UNITED STATES
DEPARTMENT OF THE INTERIOR
BUREAU OF LAND MANAGEMENT
SUNDRY NOTICES AND REPORTS ON WELLSDo not use this form for proposals to drill or to re-enter an
abandoned well. Use Form 3160-3 (APD) for such proposalsOCD
I&E - CFOFORM APPROVED
OMB NO. 1004-0135
EXPIRES: NOVEMBER 30, 2000

1a. Type of Well <input checked="" type="checkbox"/> Oil Well <input type="checkbox"/> Gas Well <input type="checkbox"/> Other _____	5. Lease Serial No. NMNM-66425
2. Name of Operator DEVON ENERGY PRODUCTION COMPANY, LP	6. If Indian, Allottee or Tribe Name
3. Address and Telephone No. 20 North Broadway, Oklahoma City, OK 73102 405-228-8699	7. Unit or CA Agreement Name and No.
4. Location of Well (Report location clearly and in accordance with Federal requirements)* SL: 1240 FNL & 2510 FWL BHL: 330 FSL & 1980 FEL PP: 1240 FNL & 2510 FWL	8. Well Name and No. Laguna Salado 22 Federal 4H
	9. API Well No. 30-015-36461
	10. Field and Pool, or Exploratory Laguna Salado; Delaware
	12. County or Parish Eddy 13. State NM

Devon Energy Production Company L. P. respectfully requests to change from Nabors Pace M-41 rig layout to McVay Rig #6.

McVay Drilling Rig No. 6

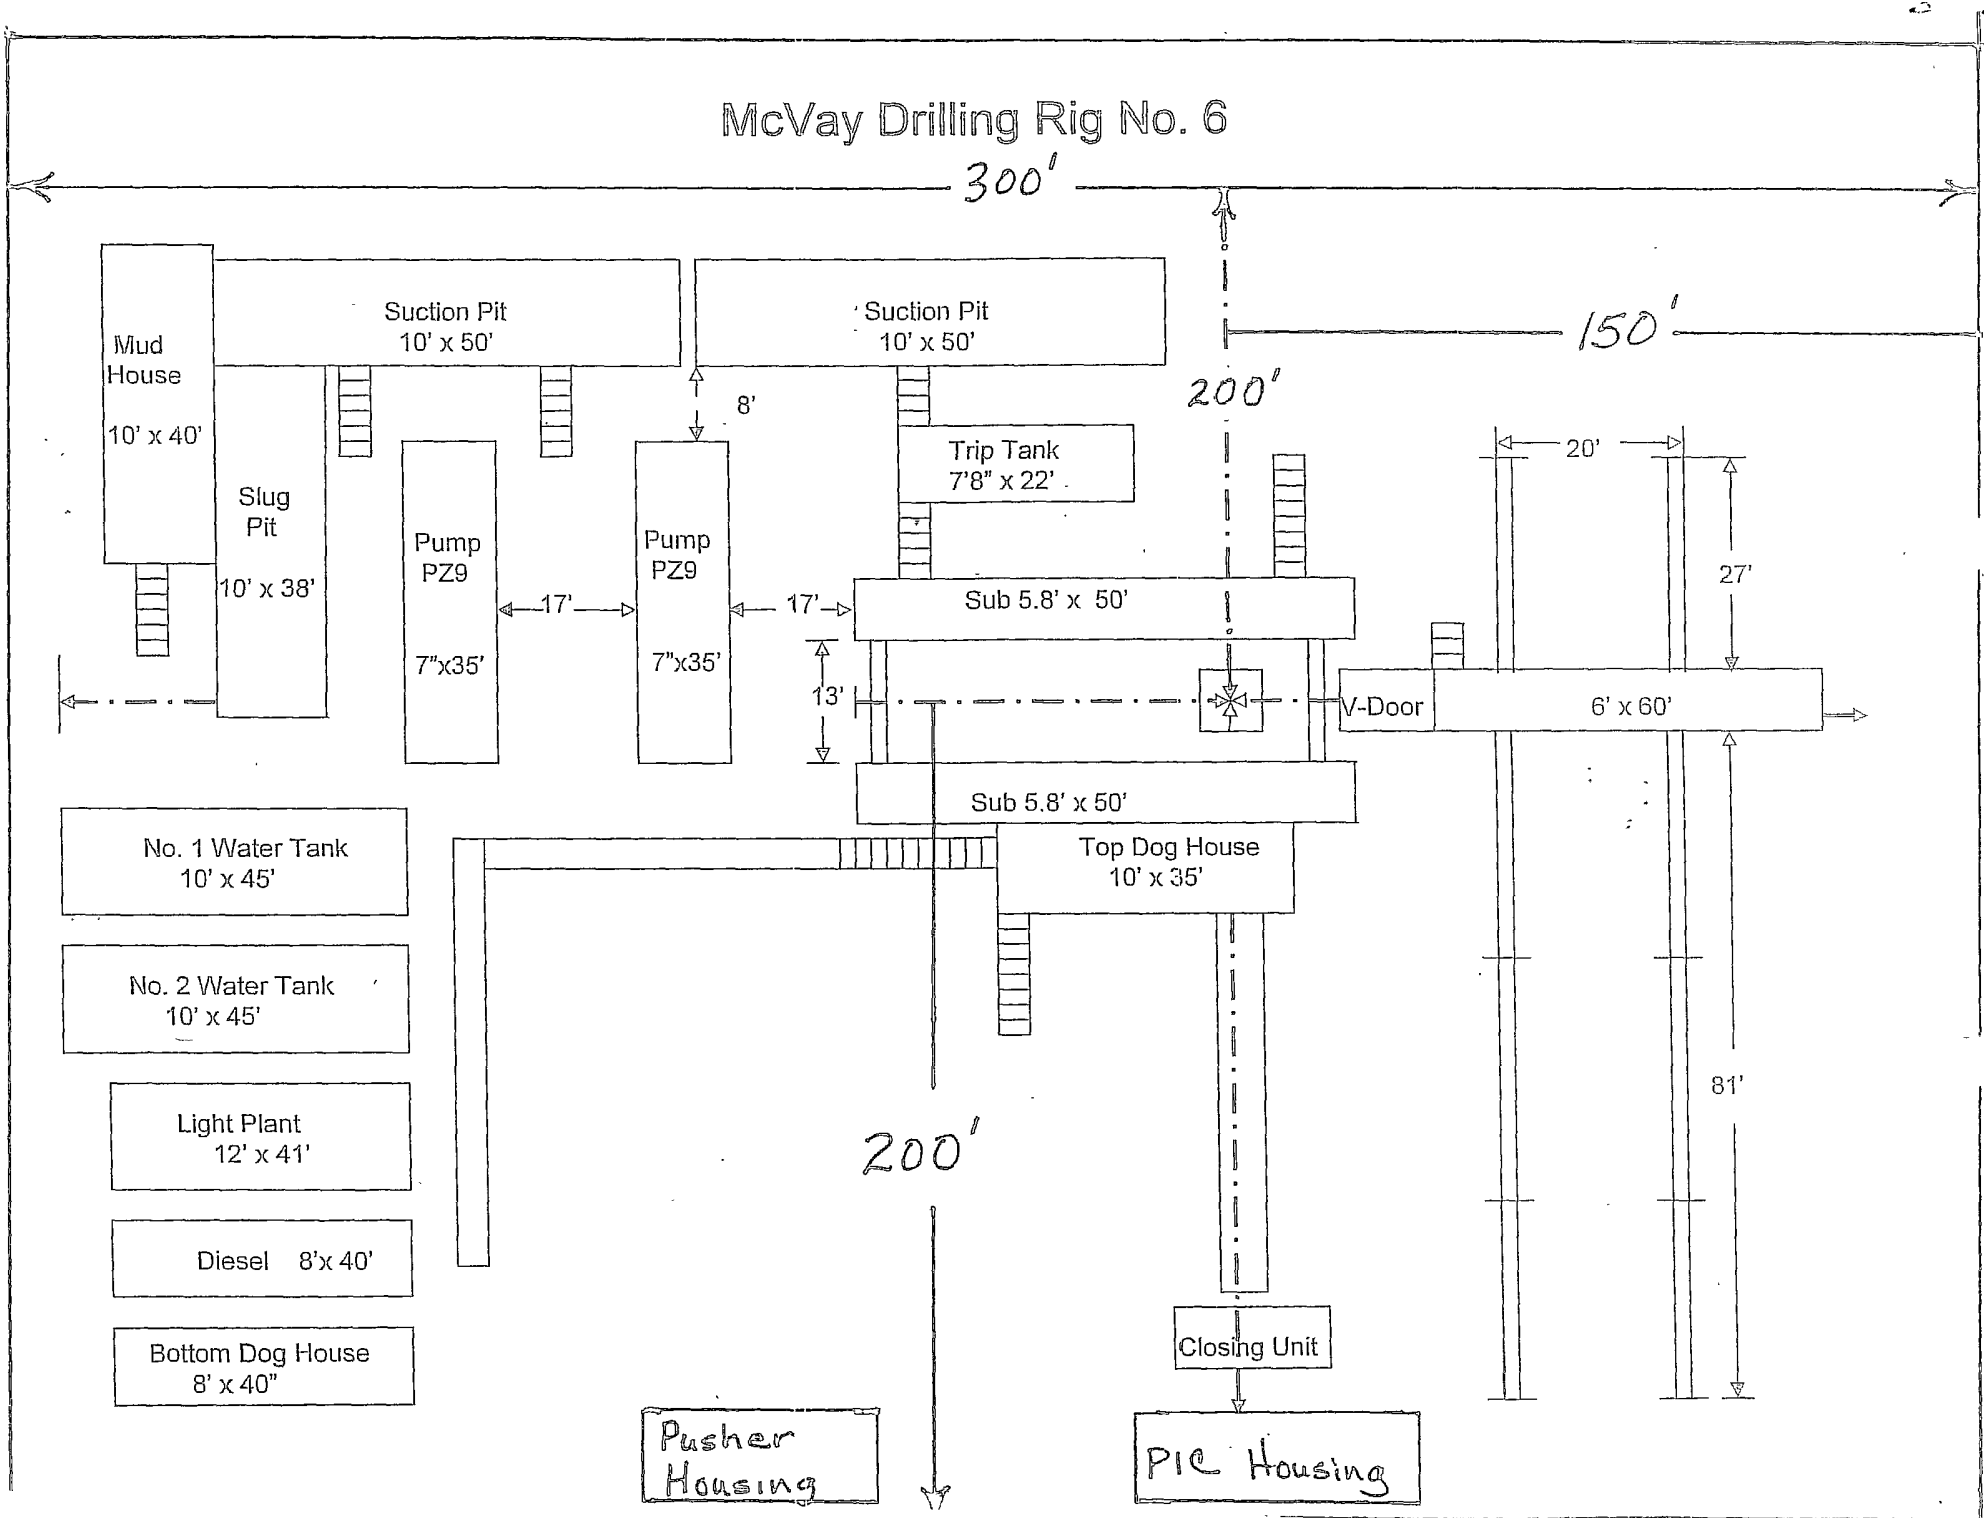
(Attached is the Rig Layout)
